Ground Water Review Form:

Application: T-12248

Applicant Name: Sage Hollow Ranch LLC

Reviewer(s): Jen Woody Date of Review: 10/06/2016, supersedes reviews dated 2/25/2016 and 3/24/2016

Figure 3. Water levels in wells in the Ordnance Basalt Critical Groundwater Area show two water bearing zones with distinct heads, and falling head with depth. See Figure 4 for well locations.

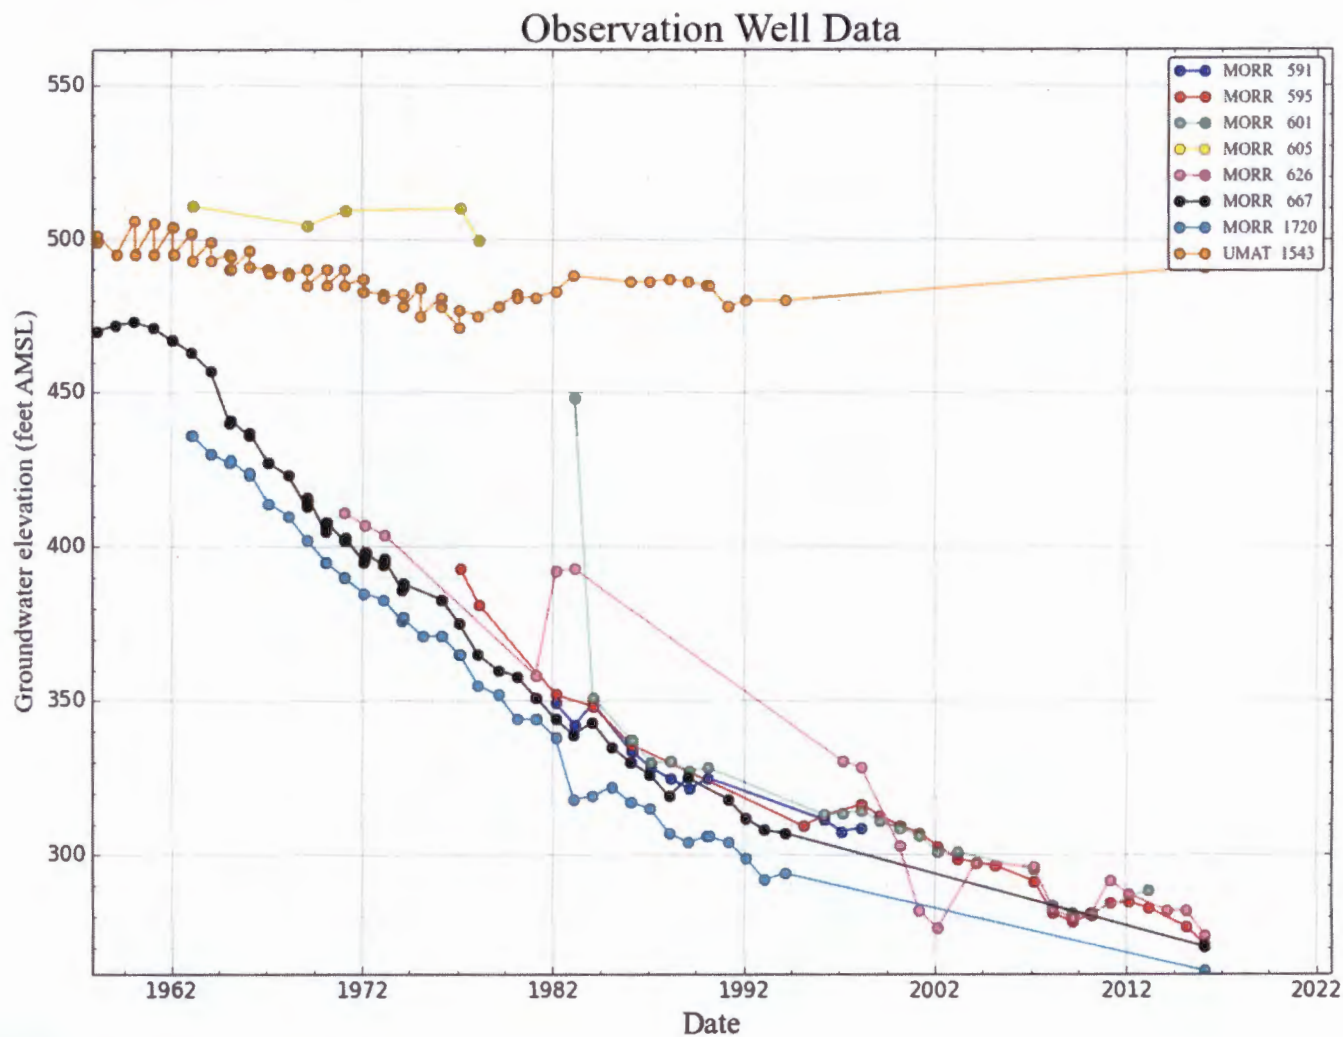
☒ Yes ☐ No There is more than one aquifer developed within the CRBG. MORR 595 and MORR 591 are constructed with 700-800 foot open intervals in the CRBG. There are at least two CRBG aquifers within 800 feet of land surface in this area. Each aquifer has a distinct head, as evidenced by UMAT 1543 and MORR 1720 which were reconstructed with casing and seal depths that allow access to a single CRBG aquifer per well (see Figure 3). The shallow CRBG aquifer accessed by UMAT 1543, is located above approximately 400 feet below land surface and has a current February groundwater elevation of 490-500 feet above mean sea level (amsl). Between approximately 400 and 800 feet below land surface, the aquifer accessed by MORR 1720 has a current February groundwater elevation of 260-280 feet amsl (see Figure 3). Cascading water has been documented by Department staff when measuring the water level at MORR 595. MORR 591 has 18' of seal reported on the log, leaving the well open to alluvium and multiple aquifers within the CRBG. To access the same aquifers with new wells that meet current well construction standards, it may be necessary to install multiple wells to replace MORR 595, for example.
